Intel® Celeron™ Processor Specification Update

Release Date: December 1998

Order Number: 243748-010

Figure 20. Side View Space Requirements for the Boxed Processor

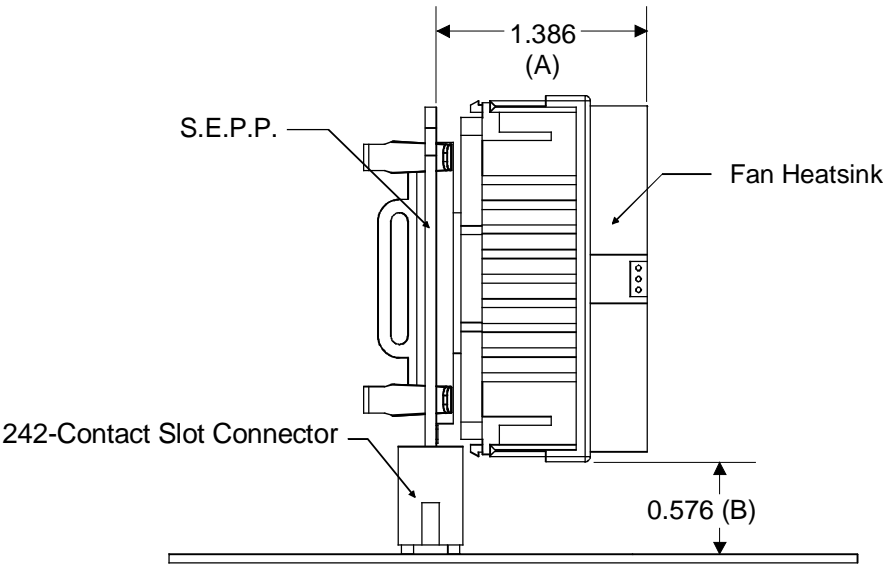
Figures 20, 21, and 22, and Table 34 of Section 6.2 of the *Intel Celeron Processor at 266 MHz, 300 MHz, 300A MHz, and 333 MHz Datasheet* show incorrect fan heat sink dimensions for the boxed Intel Celeron processor. The correct figures and table are shown below.

The maximum depth of the fan heat sink to the processor substrate should be 1.386", not 1.291" max. The minimum height clearance above the baseboard should be 0.576", not 0.485". The fan shroud height should be 2.02" and 4.74", respectively, not 2.19" max. and 4.90" max. Figure 22 should show reference "G" for the minimum airflow keepout zone from the inlet of the fan heat sink, and reference "F" for the minimum airflow keepout zone from the ends of the fan heat sink.
